RE: Homestake Mining Company of California
– License SUA-1471
Grants Reclamation Project
Responses to NRC Request for Additional Information (RAI) dated 6/13/07

HOMESTAKE MINING COMPANY RESPONSES TO
Request for Additional Information, Homestake Mining Company,
Grants Reclamation Project
From the Nuclear Regulatory Commission

**SUBJECT: RESPONSE TO NRC REQUEST FOR ADDITIONAL
INFORMATION, COMMENT #2 REGARDING EMBANKMENT SLOPE
STABILITY OF EP3 EMBANKMENT**

Homestake Evaporation Pond Number 3: Response to NRC Request for Additional Information Comment No. 2

Figure 1. General EP3 Soil Profile for SLIDE Analysis

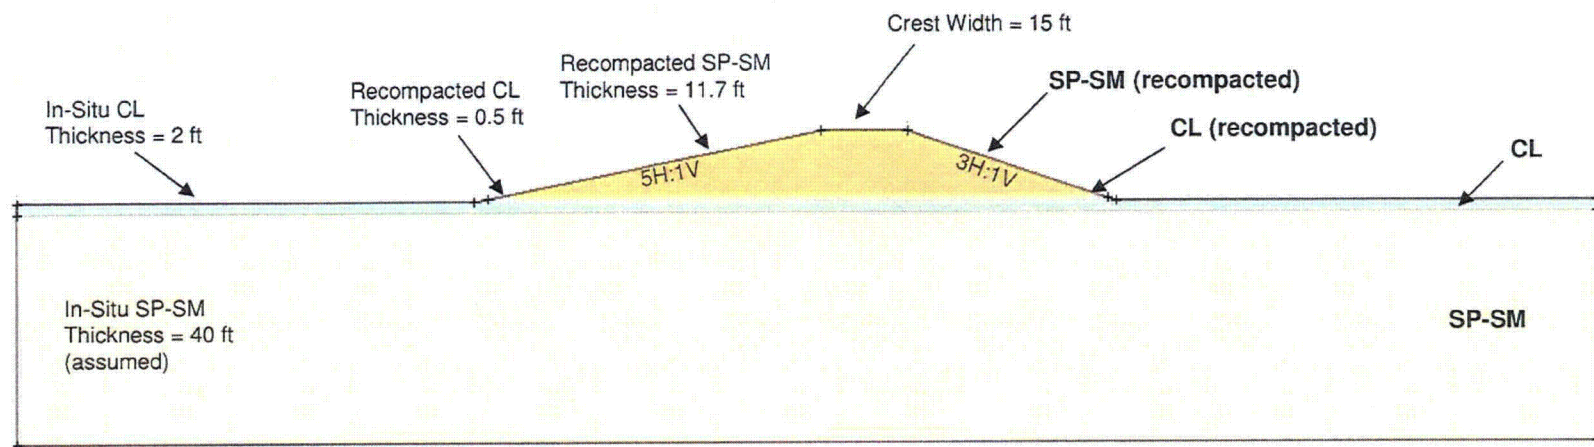
A slope stability analysis was performed on the southern-most corner of EP3. Results are shown on Figures 1 through 17, Attachment A. This location was chosen because it represents the area with the greatest amount of fill material and the corresponding largest embankment height of 12.2 feet. The in-situ soil thickness was determined from test pits SW-3 and SW-4 soil logs included in Attachment B of this response. These test pits are located near the southern corner of EP3; the test pit location map (Figure 17) is also reproduced in Attachment B. These logs show a surface lean clay (CL) layer thickness of 2 feet underlain by a poorly graded sand with silt (SP-SM) material.

The pond embankment will be composed of recompacted lean clay (CL) and poorly graded sand with silt (SP-SM) material. It is likely that the lean clay will be placed in a lift below the SP-SM soil as shown in Figure 1 located in Attachment A of this response. The thickness of the recompacted materials was determined from the embankment design section.

Figure 2. Phreatic Surface 1

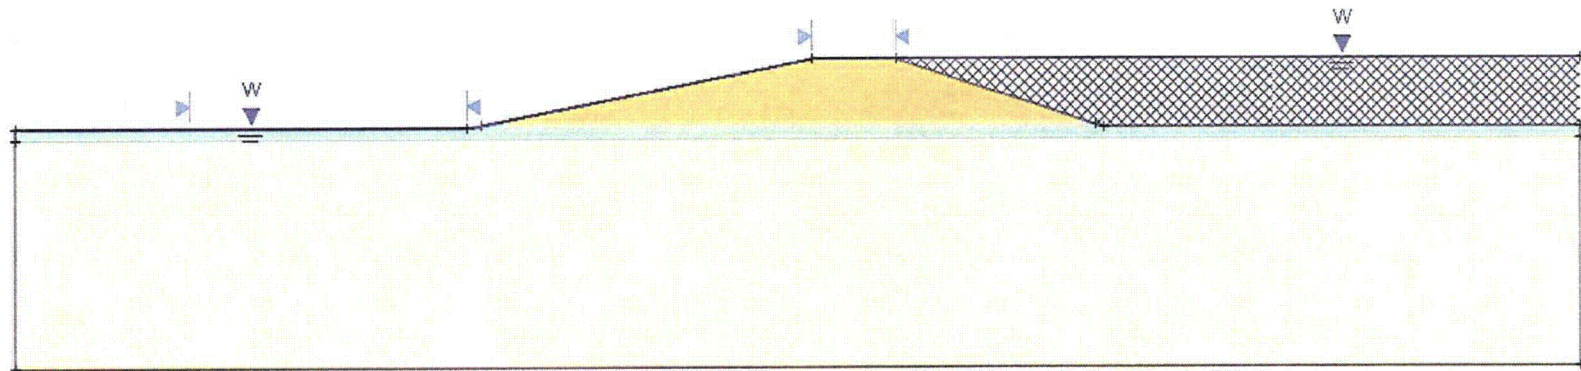
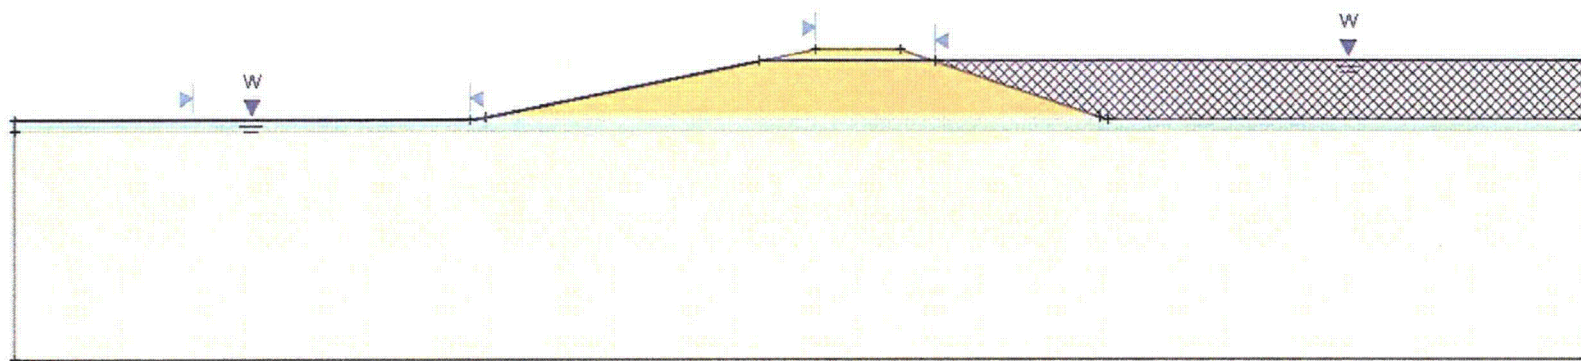
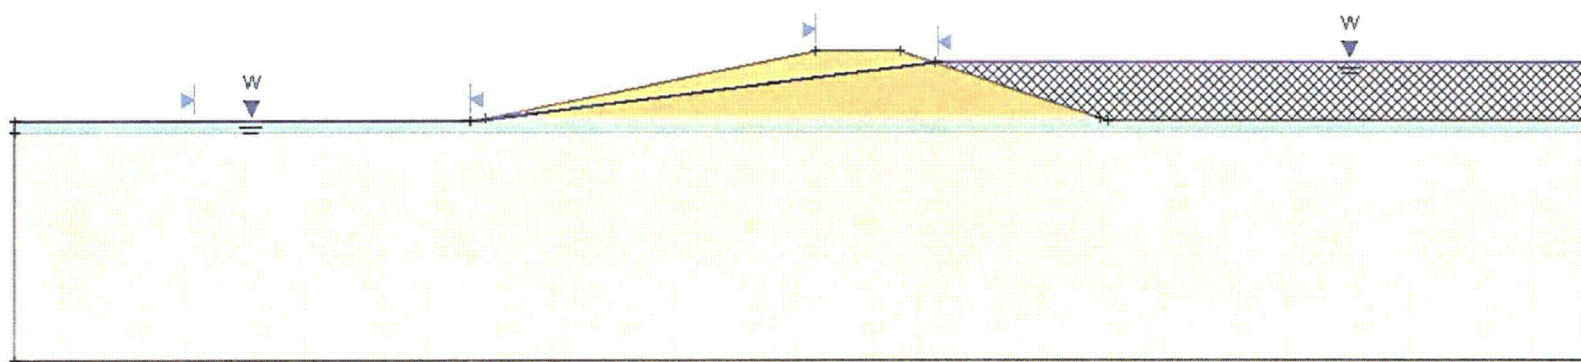
Slope stability analysis was performed assuming three phreatic surface variations as shown in Figures 2 through 4 of this response. The first phreatic surface represents a

completely saturated embankment. The second phreatic surface represents a water level equal to the maximum allowable water height, namely, a freeboard of 2 feet with saturation extending to the slope. The third scenario also represents a freeboard height of 2 feet but has the phreatic surface extending to the outslope toe. A minimum factor of safety for each scenario was determined using SLIDE. Results of the static slope stability analysis are presented in Table 2 and Figures 5 through 10 and figure 17.

Figure 5. Static Analysis: Phreatic Surface 1, Simplified Bishop Method

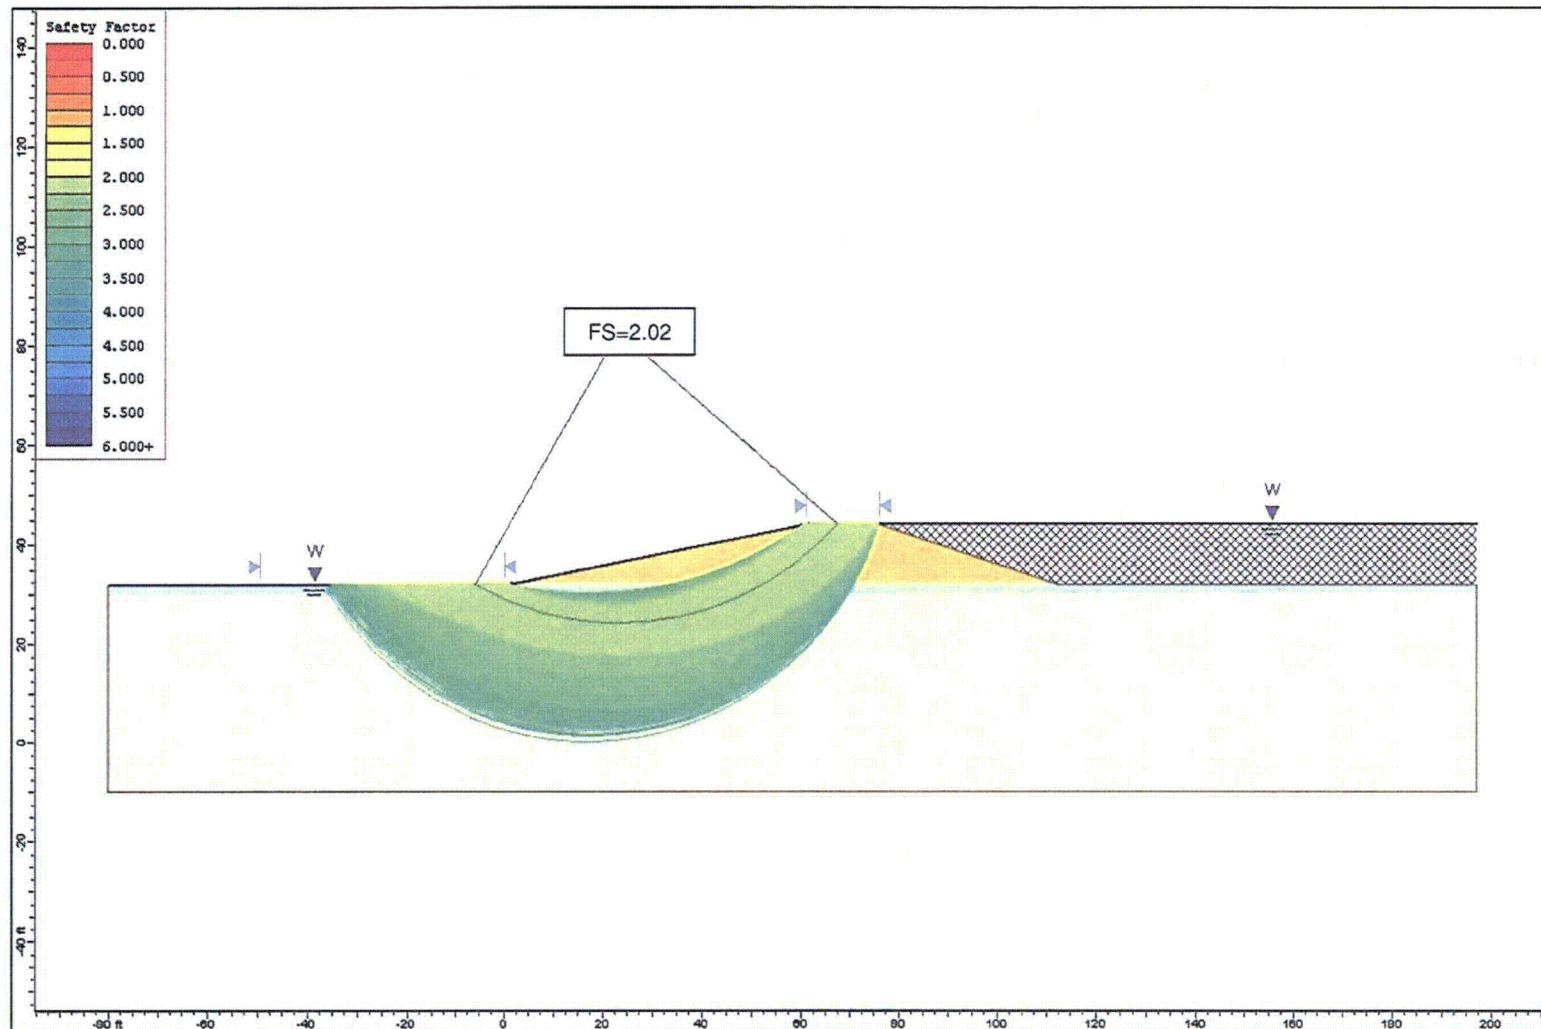
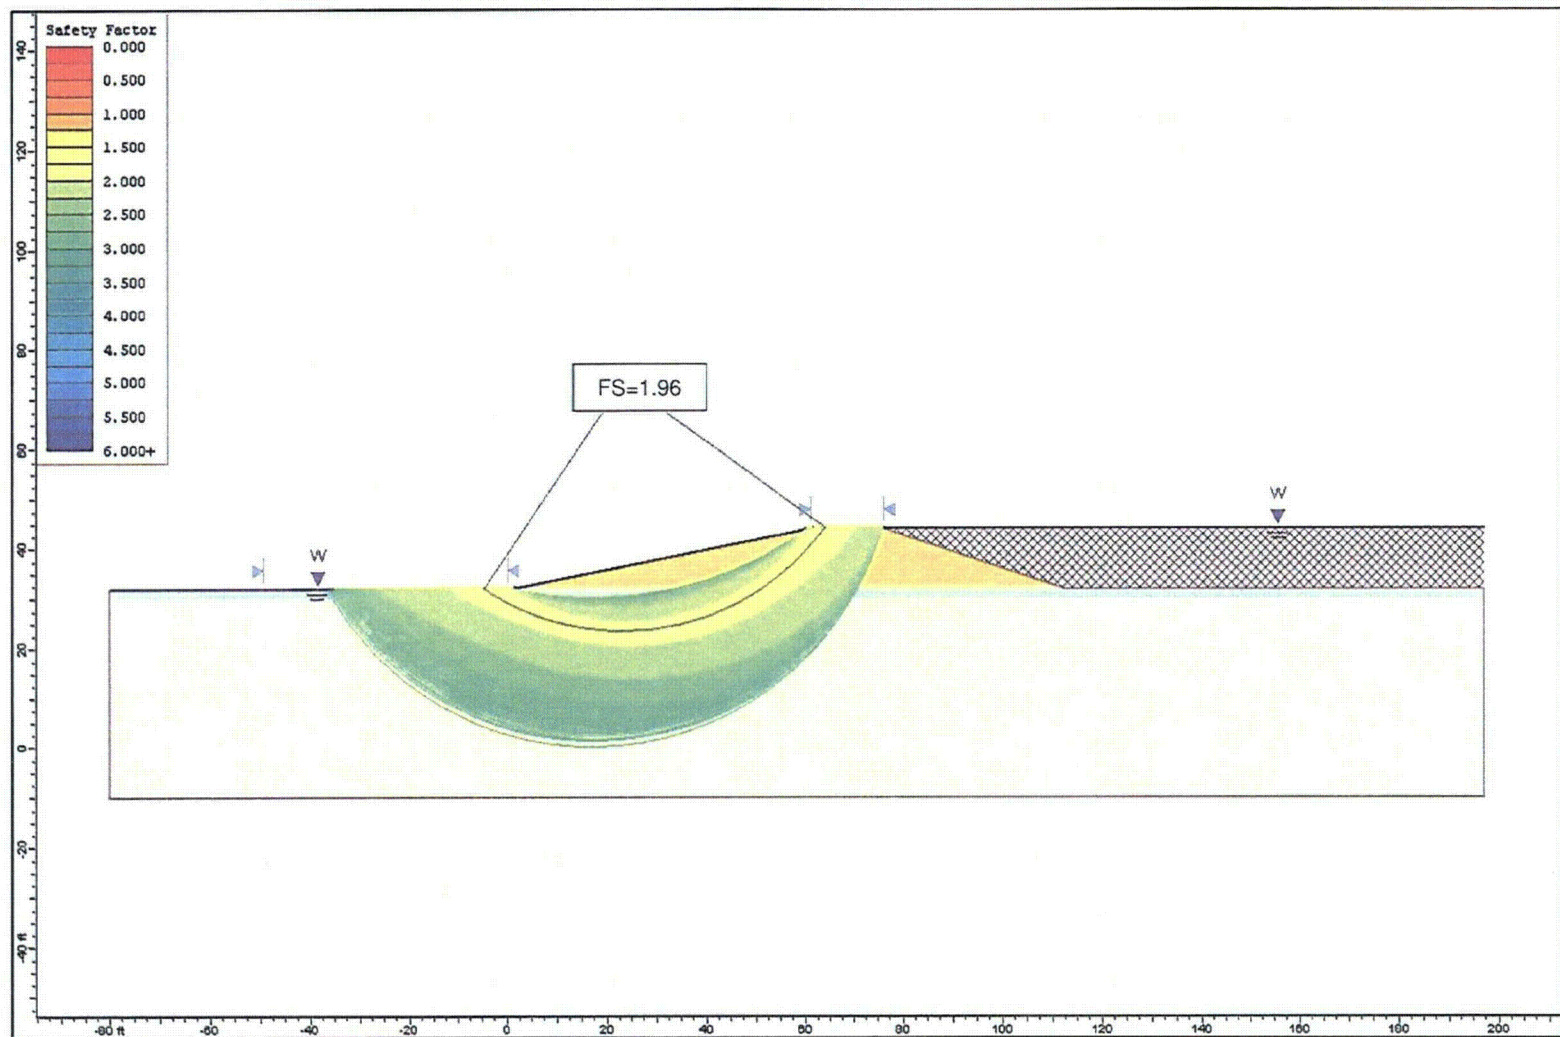
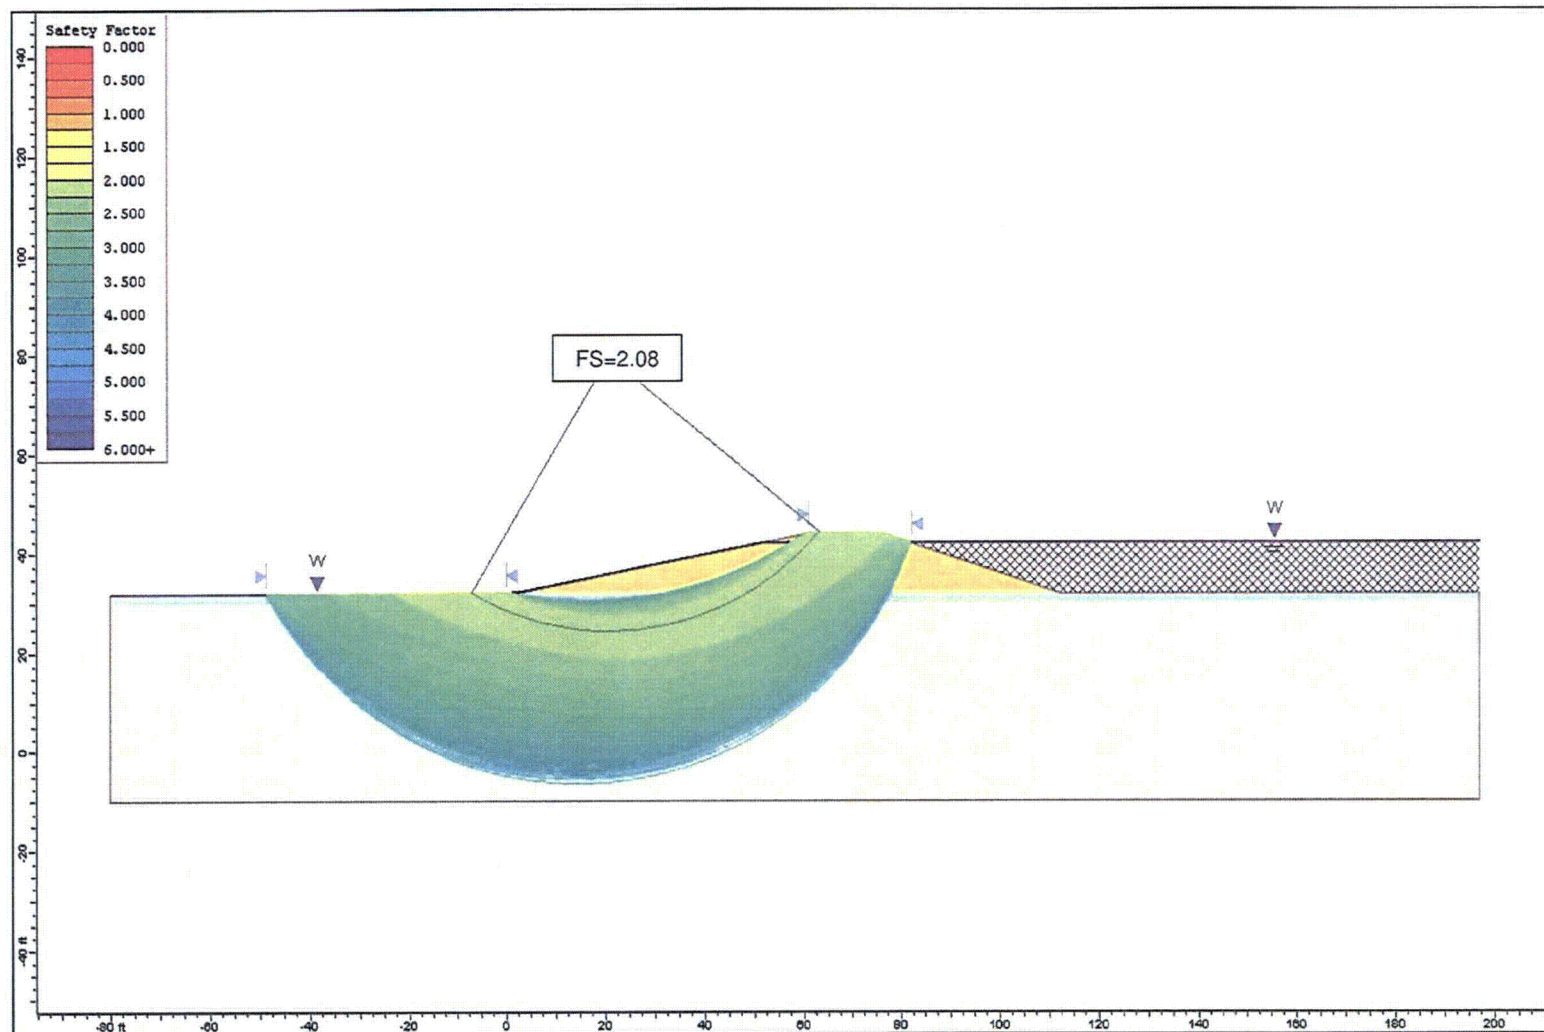
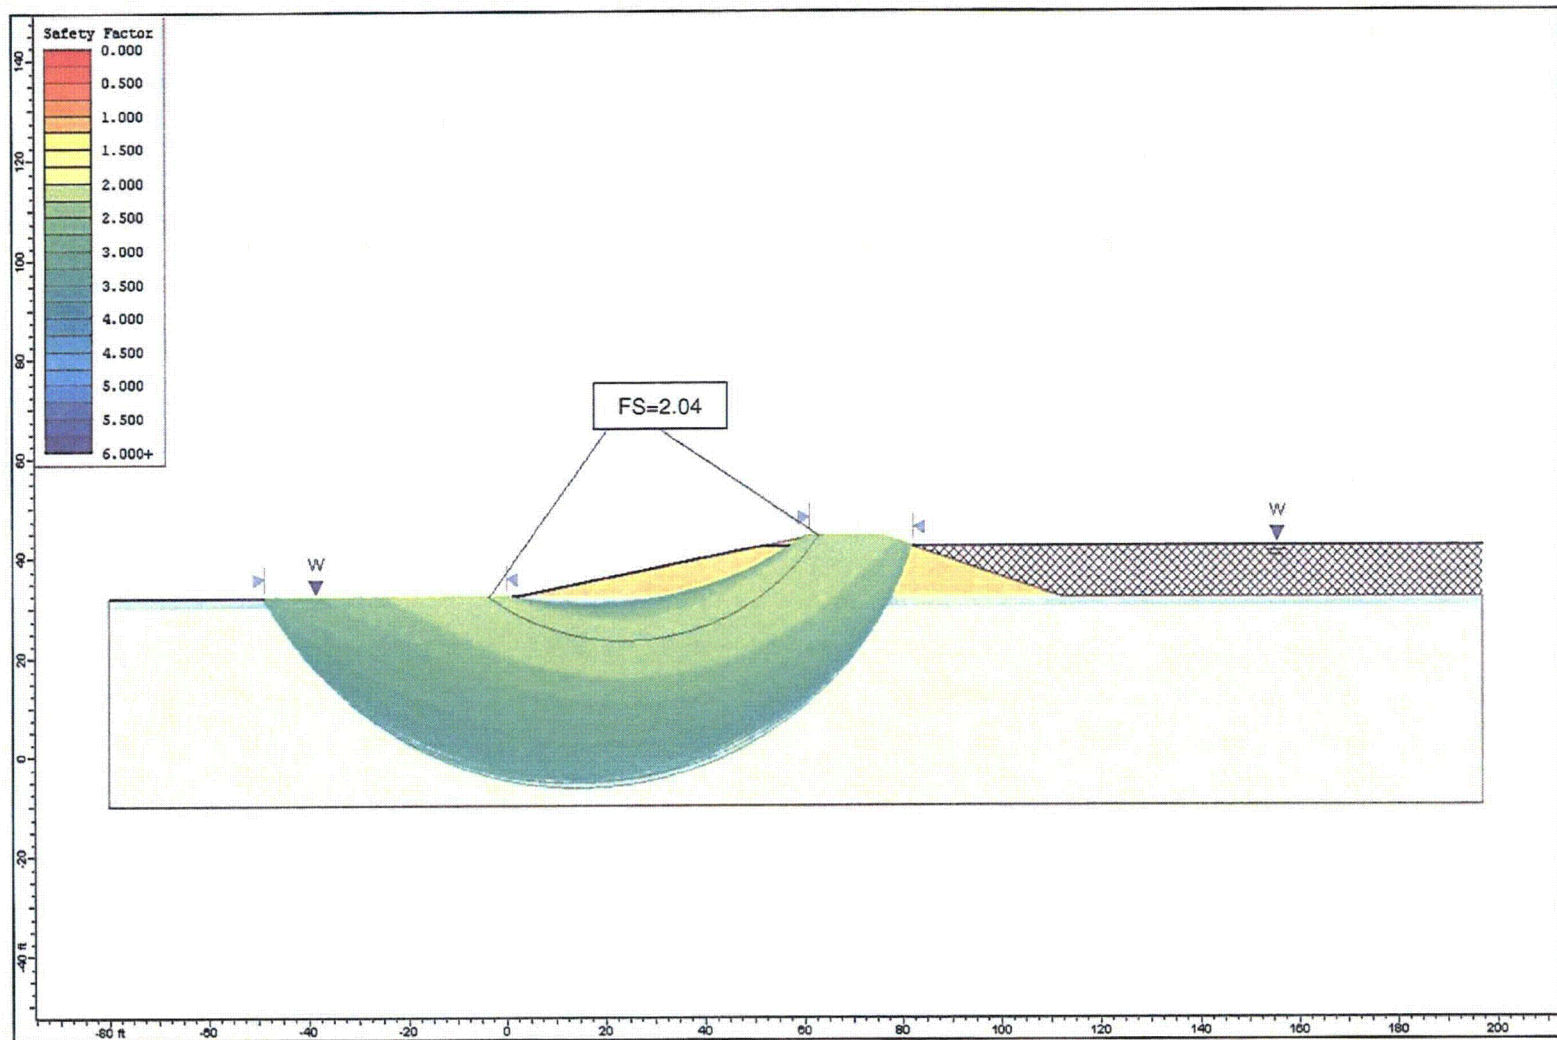
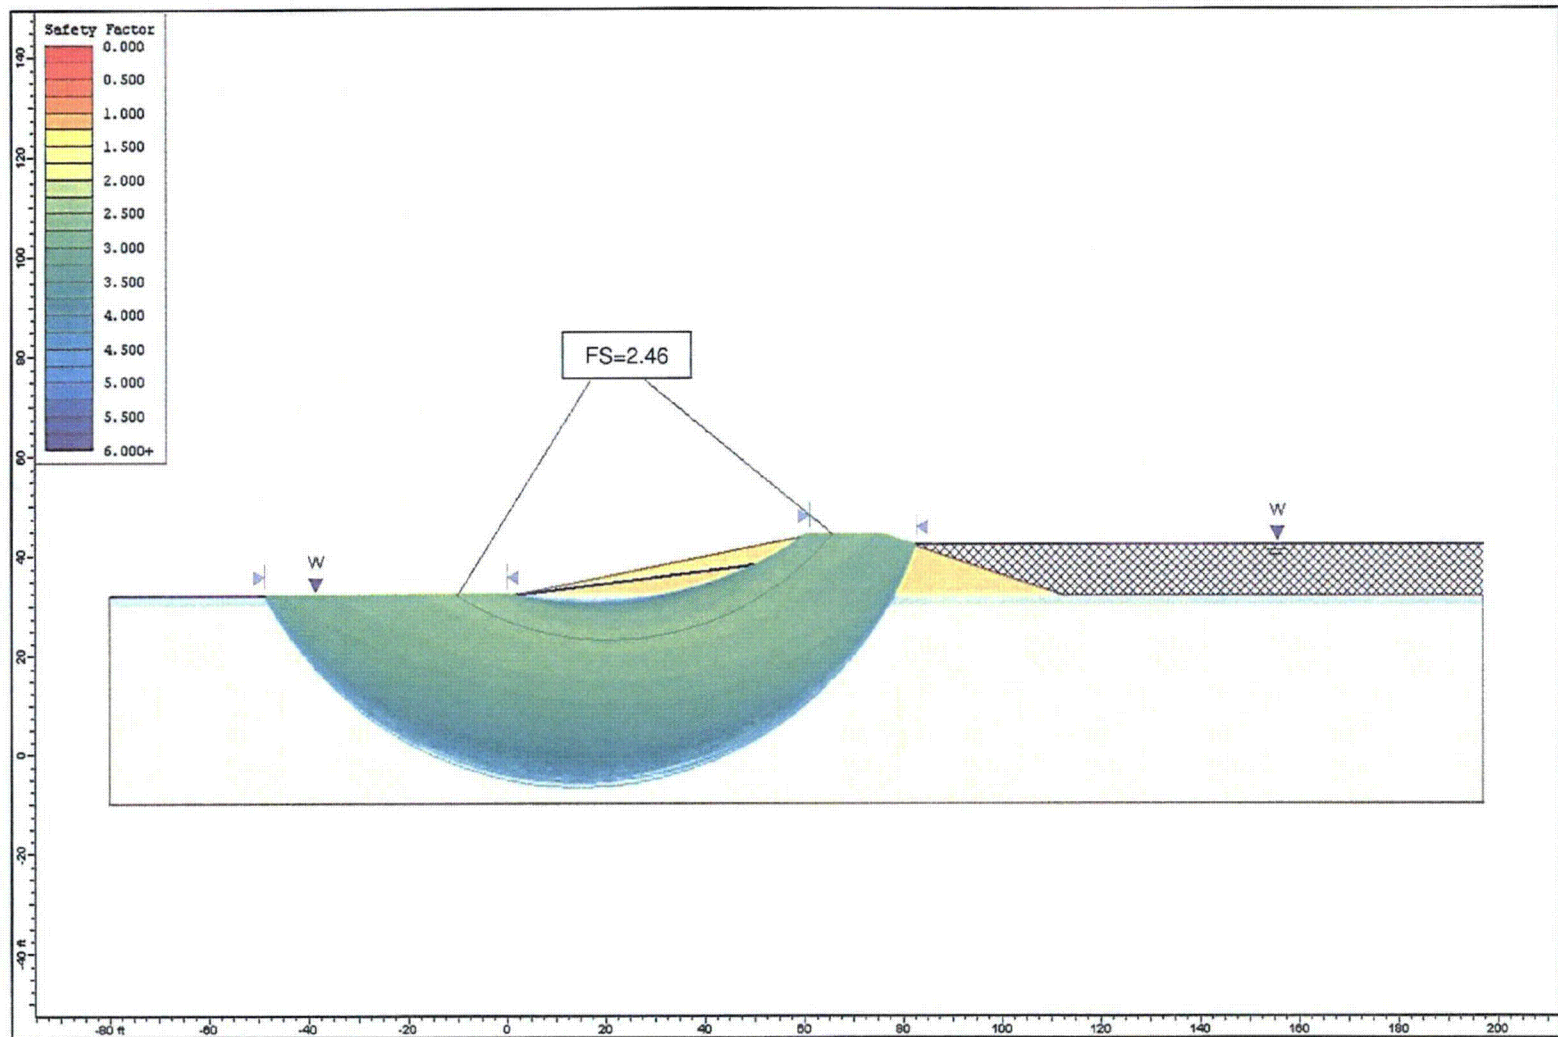
Slope stability analysis was performed using the SLIDE program (Reference 4) to determine a minimum static factor of safety for the EP3 embankment. The Simplified Bishop and corrected Janbu methods were used in the analysis, and a circular failure plane was assumed. The failure initiation limits were confined to the water surface intersection with the inslope and the outer crest of the embankment. The failure termination limits were confined to the outslope toe and 50 feet beyond the toe. These limits were assigned in order to confine the analysis to failure surfaces that would cause loss of pond water containment. Termination limits are shown in Figures 2 through 4. A total of 960 trial failure surfaces were searched within these limits.

The scenario where the embankment becomes fully saturated and all cohesion is lost in the clay is presented in Figure 17 and represents a complete loss of soil suction.
